Kalamazoo River SRI Phase 2 Core Analyses – Focused Step-out Sampling – Crown Vantage Landfill to Plainwell No. 2 Dam

CH2M HILL COMMENTS ON THE KALAMAZOO RIVER SRI PHASE 2 CORE ANALYSES – FOCUSED STEP-OUT SAMPLING – CROWN VANTAGE LANDFILL AREA RESPONSE TO COMMENTS ALLIED PAPER, INC/PORTAGE CREEK/KALAMAZOO RIVER SITE

RESPONSE TO COMMENTS ON THE PROPOSED SRI PHASE 2 CORE ANALYSES FOCUSED STEP-OUT SAMPLING PLAN FOR THE KALAMAZOO RIVER FROM CROWN VANTAGE LANDFILL TO PLAINWELL NO. 2 DAM

Figure 1 - Focused Step-out Sampling Locations

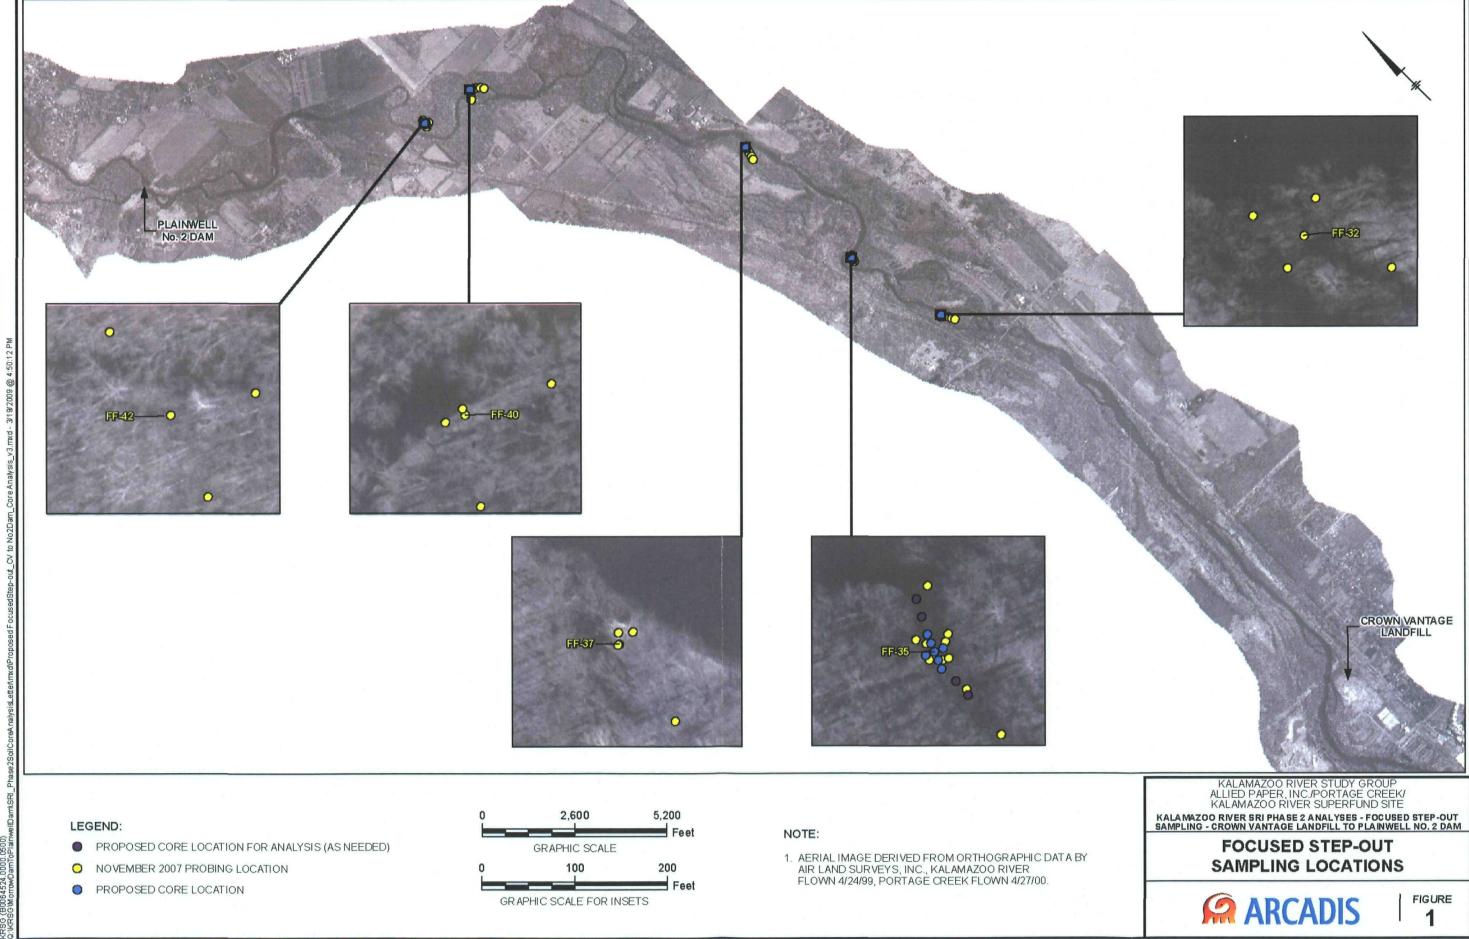
The first sentence of the third paragraph should be revised to indicate that 30-foot step-outs will be collected "at FF-32, FF-37, FF-40, and FF-42", instead of

"at each location".

Comment 5) The sample grid layout was left open as indicated by the fact that it "...may be in a radial pattern, a grid-based pattern, or other design, as appropriate and as approved by USEPA, and may not necessarily be geographically centered on the original focused sample location." This points to the fact that it was assumed that the FF samples may not be located in the center of a depositional feature and that the size and shape of the depositional feature could not be understood until after the field reconnaissance was completed. Clearly, the sampling plan was not intended to be a simple step-out sampling exercise; otherwise, what is the purpose of leaving such details open to interpretation for a later date?

Response: Based upon discussion with USEPA and MDEQ during the March 16, 2009 teleconference, only one focused sample location (FF-35) will be sampled. The text has been revised to reflect this.

Response: Agreed. As reflected in the layout of the proposed sampling at location FF-35, we do not assume it is in the center of the deposit.
